DAIMLER ARMOURED CAR

TECHNICAL HANDBOOK - MODIFICATION INSTRUCTION

Preparation for fitting wireless set C12

Fig 1 - Fixing of ammunition carrier

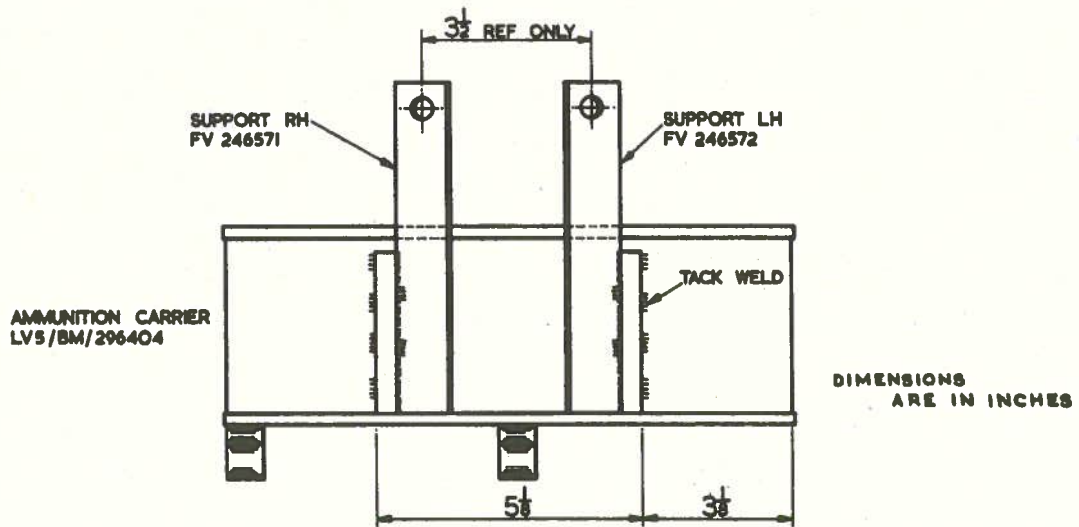
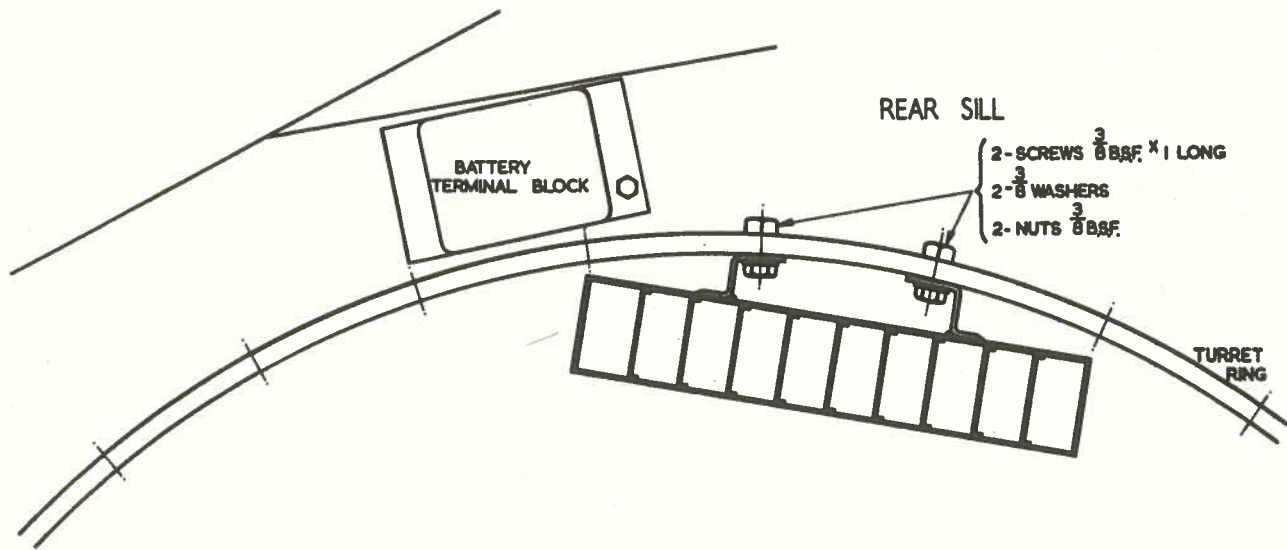
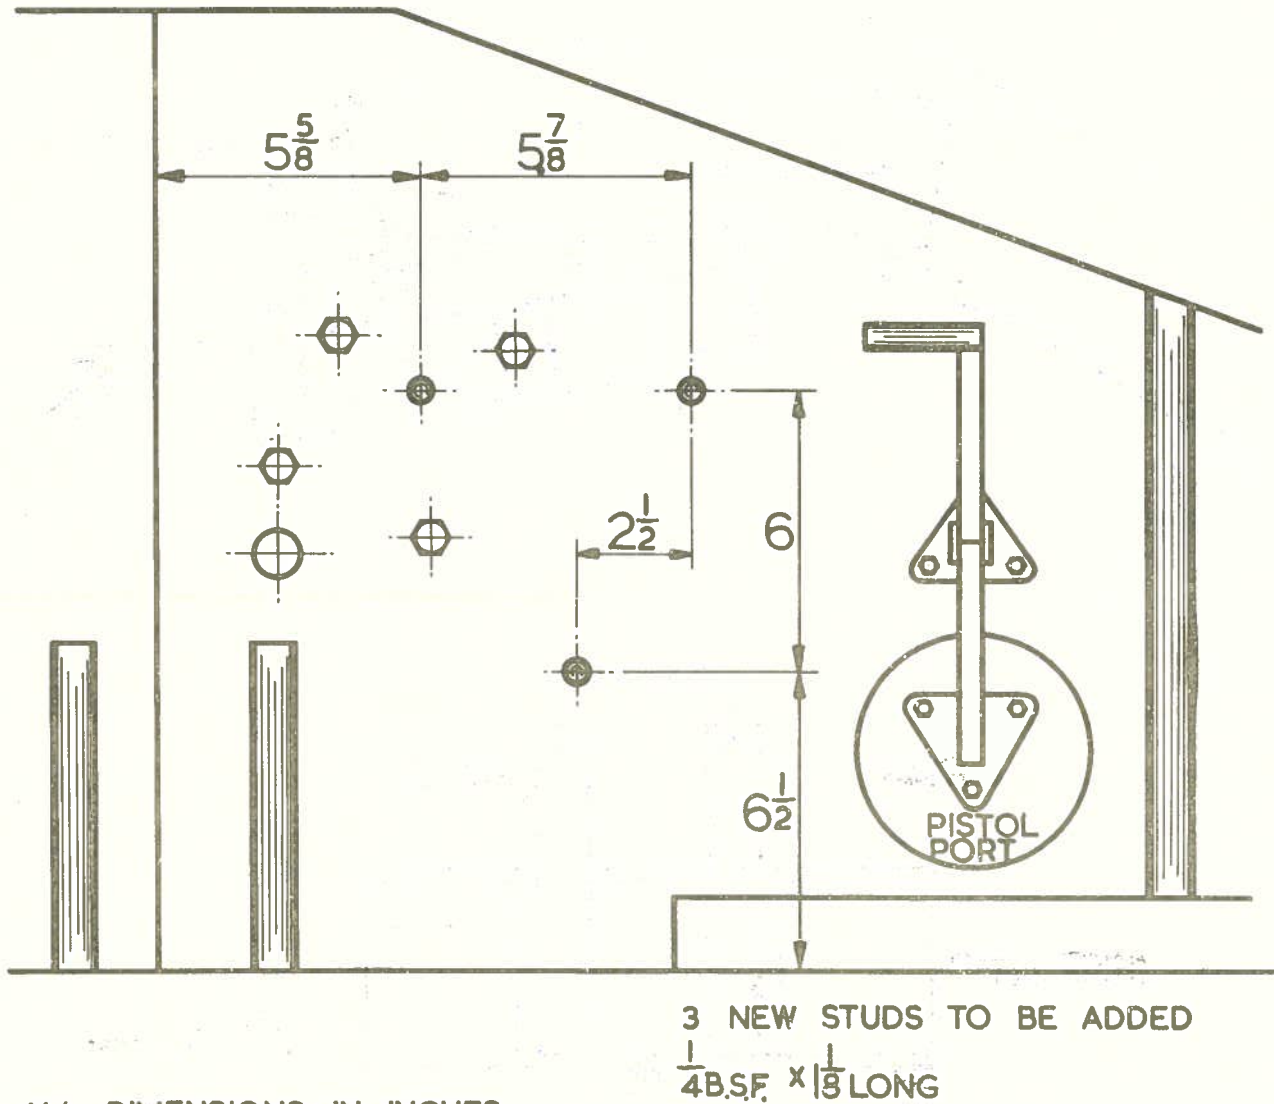
8. (a) Remove the MG ammunition carrier from the right-hand wall of the turret by unscrewing its three fixing nuts, these nuts will be replaced, as they are used also to secure an external bracket.
- (b) Remove and discard the securing bracket which is riveted to the carrier.
- (c) Weld the right-hand support (FV 246571) and the left-hand support (FV 246572) to the carrier as shown in Fig 1.
- (d) Secure this assembly to the turret ring as shown in Fig 1, two replacement  $\frac{3}{8}$  in. B.S.F. nuts and screws are provided should the original nuts and screws become damaged during removal.

Fig 2 - Position of studs turret r.h. wall

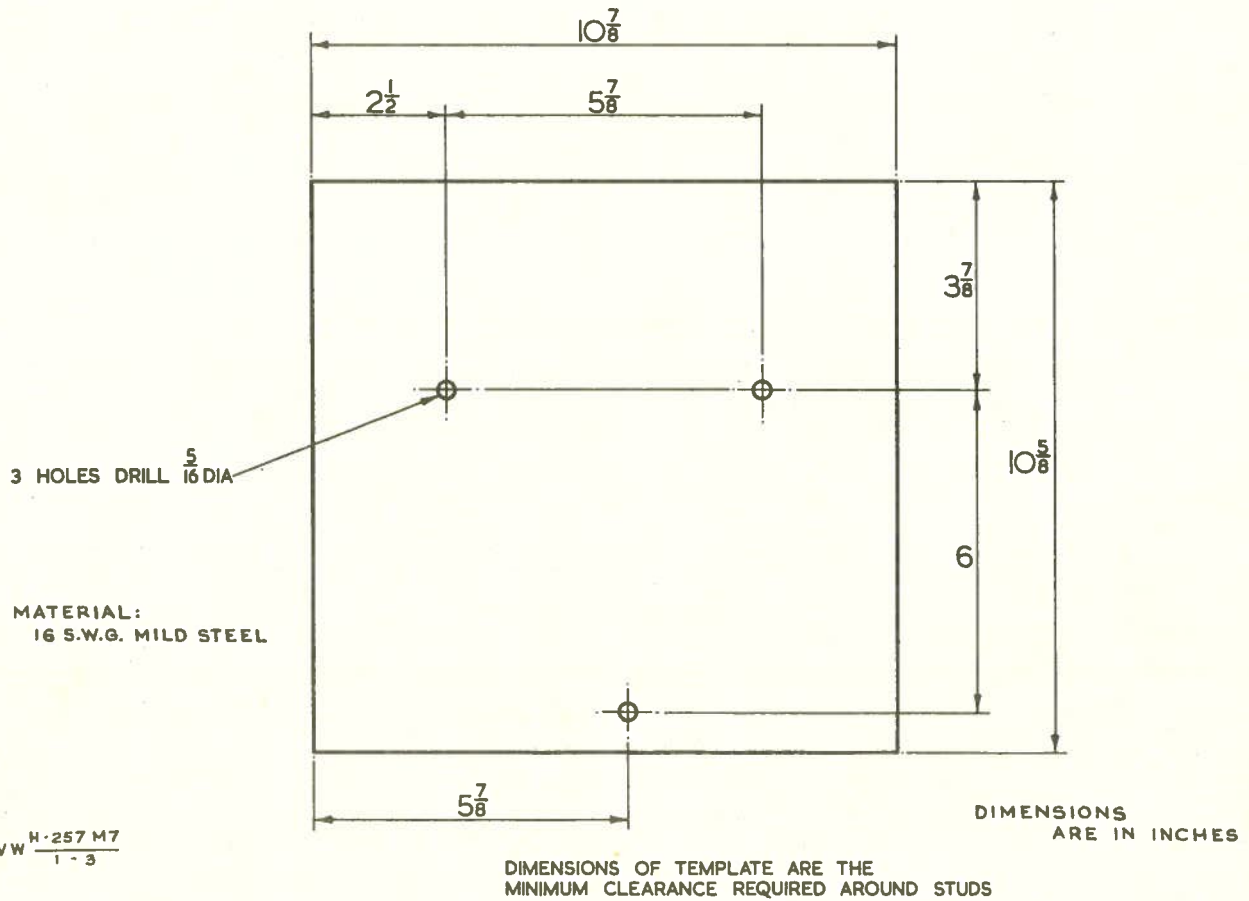
9. Weld three  $\frac{1}{4}$  in. B.S.F. x  $1\frac{1}{8}$  in. studs to the right-hand wall of the turret as shown in Fig 2. When marking out use the template in Fig 3 (to be made up locally) to ensure that the stud positions will give adequate clearance around the aerial tuning unit which will later be fitted on the studs. The template should be fitted over the studs when welded to check accuracy of positioning.
